Subject: Mechatronic Transmission Module (MTM) Update – Endurant HD and PACCAR TX-12

Document Number: TAIB-1001

Date: July 1, 2022

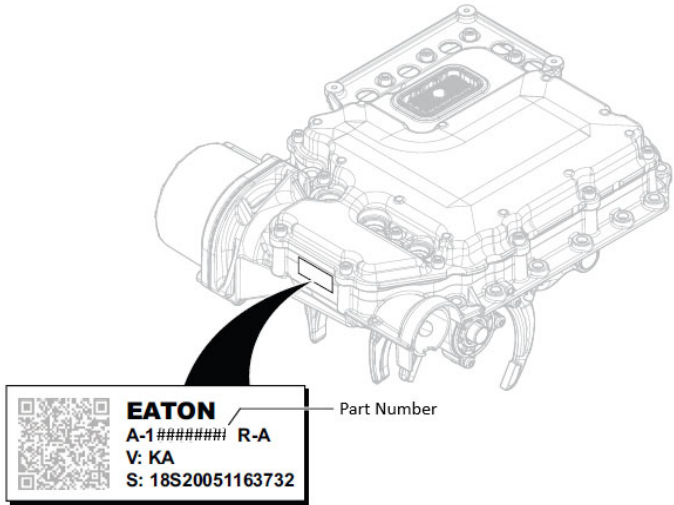
An updated MTM is to be released to production and service. Changes include updated solenoids, internal harness, and the addition of an oil temperature sensor. Additionally, remanufactured MTMs were released to be used with warranty claims associated to PS-393 MTM Type repairs.

- Configuration parameter added to TCM software – MTM Type with the following settings:
 - PS-393 (Original)
 - PS-496 (New)
 - When TCM software is updated to 5516042 or greater on original equipment units the MTM Type is set to PS-393.

- Service Manual (TRSM0950):
 - If an original equipment MTM (PS-393) is replaced with an updated MTM (PS-496), the MTM Type configuration must be changed in the TCM with ServiceRanger.
